Illustrative Development Plan

Area E

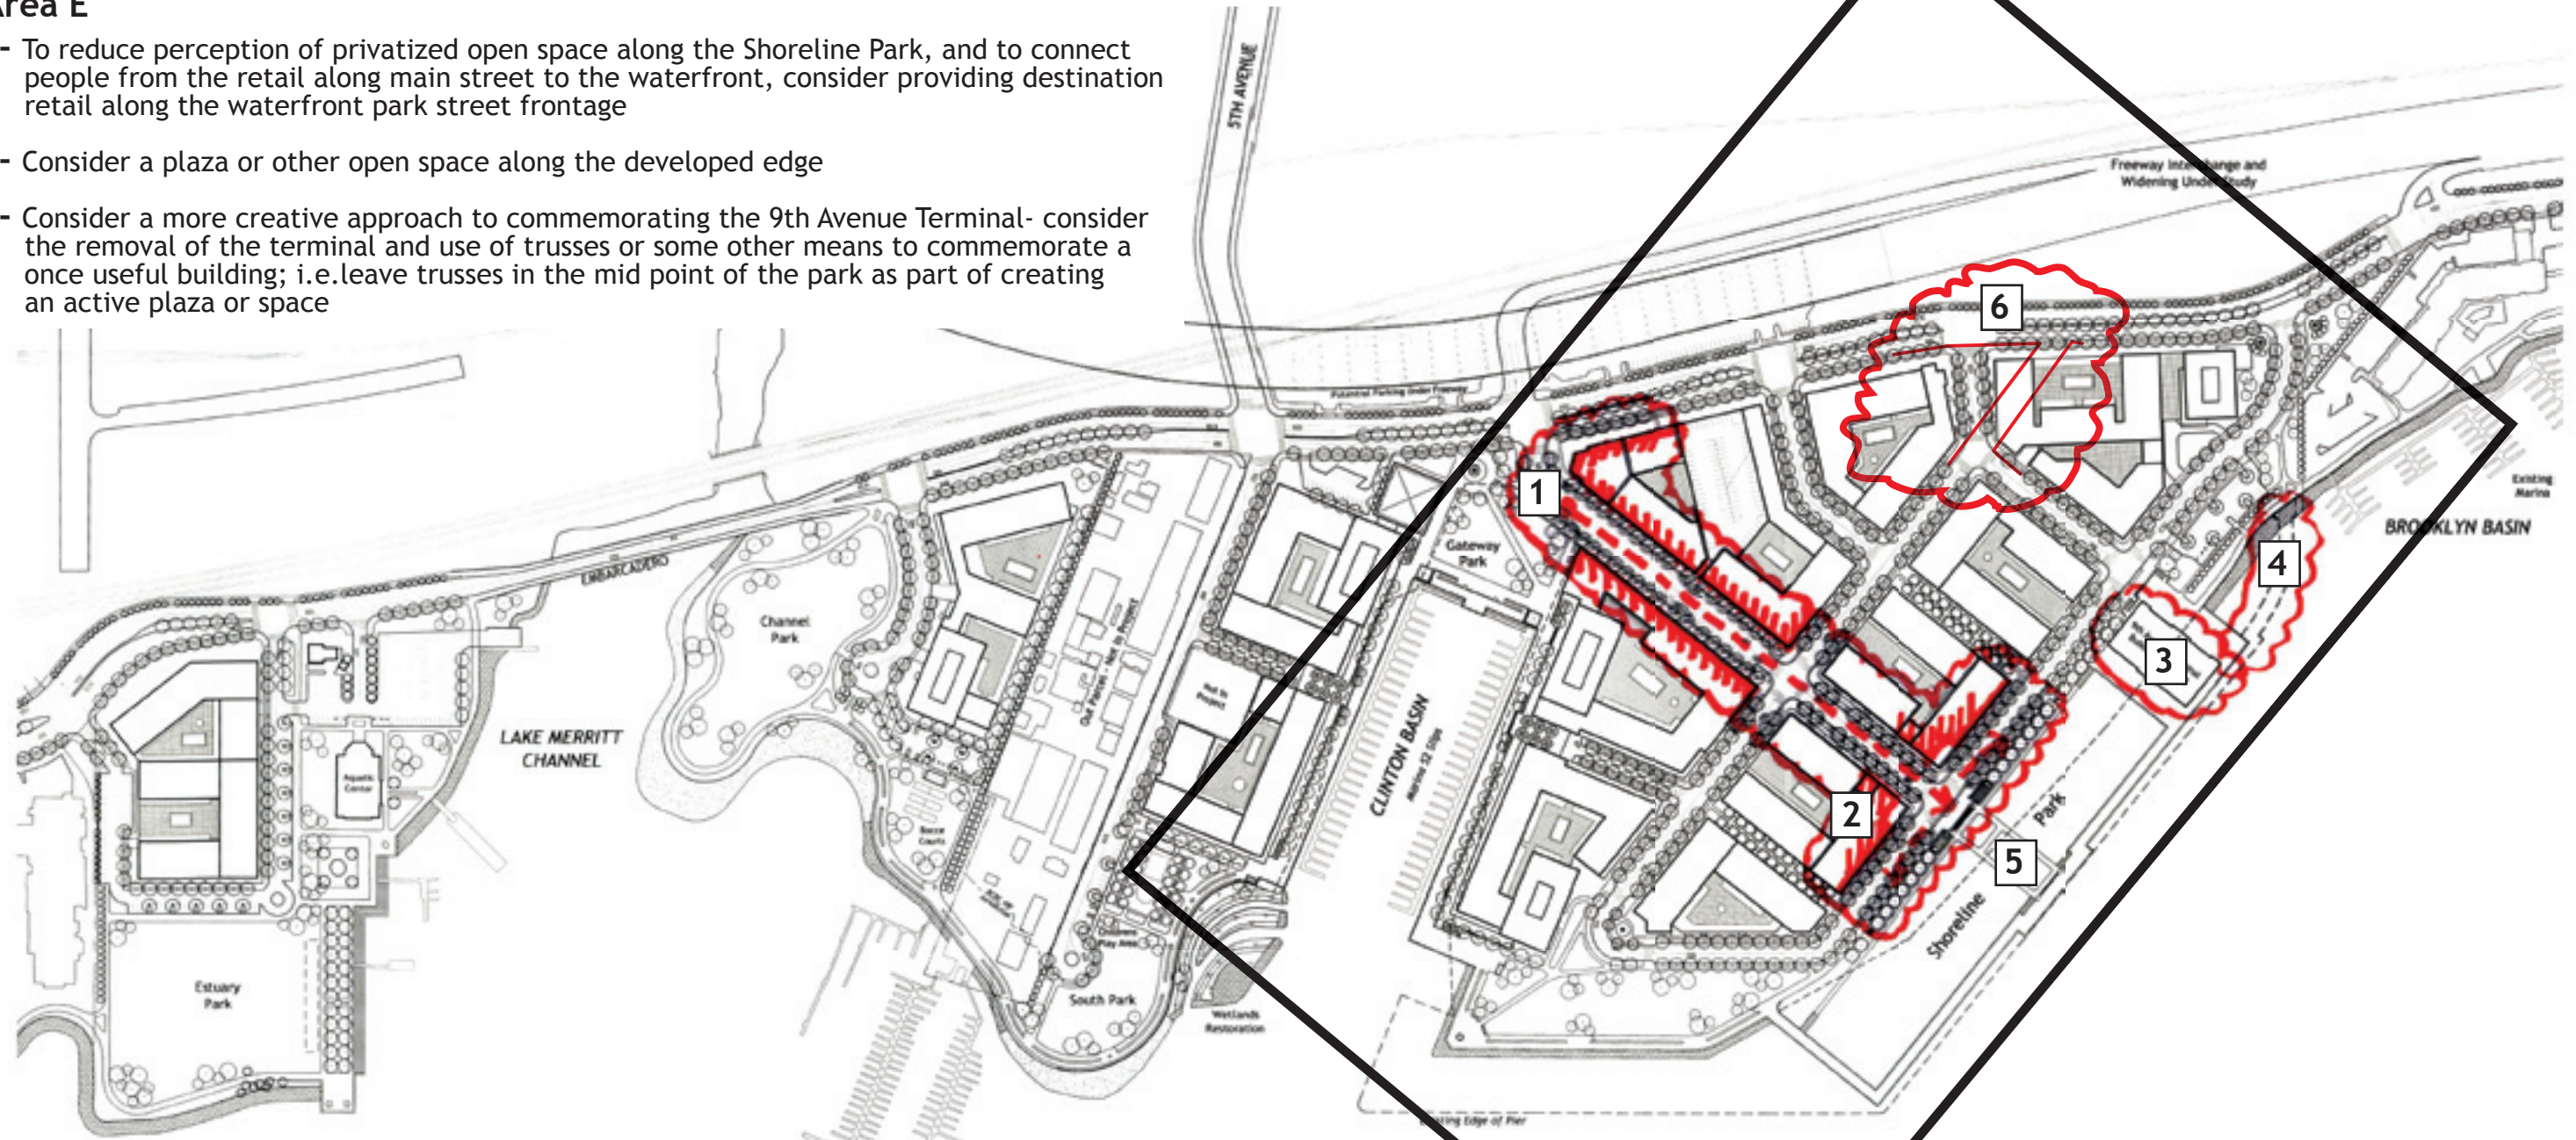
- 1- To reduce perception of privatized open space along the Shoreline Park, and to connect people from the retail along main street to the waterfront, consider providing destination retail along the waterfront park street frontage
- 2- Consider a plaza or other open space along the developed edge
- 3- Consider a more creative approach to commemorating the 9th Avenue Terminal- consider the removal of the terminal and use of trusses or some other means to commemorate a once useful building; i.e. leave trusses in the mid point of the park as part of creating an active plaza or space

- 4- Consider keeping the existing access to the terminal by preserving/ renovating the wooden bridge
- 5- Urban design program for Shoreline Park:
 - active uses to the East
 - Passive uses to the West
- 6- Consider realigning road to offer direct views to the waterfront from the Embarcadero
